[Docket No. FAA-2007-28688; Directorate Identifier 2005-SW-21-AD; Amendment 39-15312; AD 2007-26-10]

Airworthiness Directives; Bell Helicopter Textron Canada Model 430 Helicopters

ACTION: Final rule.

Figure 1

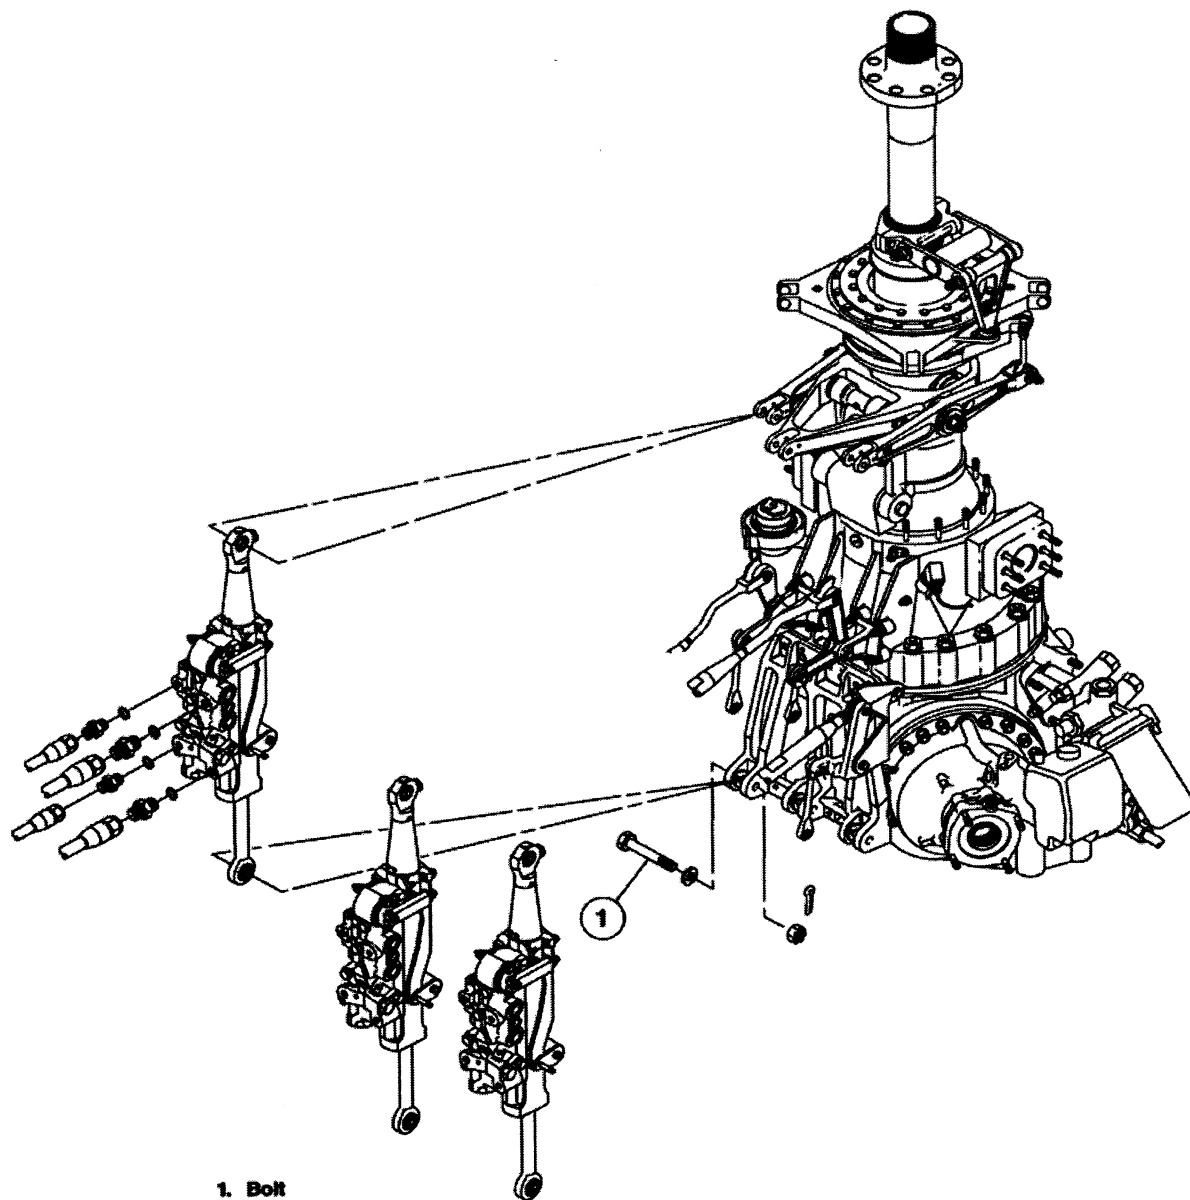
- (a) Within 150 hours time-in-service (TIS), replace all three affected bolts, as depicted for one of these bolts in Figure 1 of this AD, with airworthy, zero-time bolts, P/N 50-047C8-31.

Note 1: Only the right servo lower attach bolt (1) is shown. The collective and left cyclic servo lower attach bolts are also to be replaced. (This AD does not apply to the same part-numbered bolts at the upper end of each servo.)

(b) This AD revises the Airworthiness Limitations section of the maintenance manual by establishing a retirement life of 5000 hours TIS for each bolt.

(c) Record a 5000-hour TIS life limit for each bolt on the component history card or equivalent record.
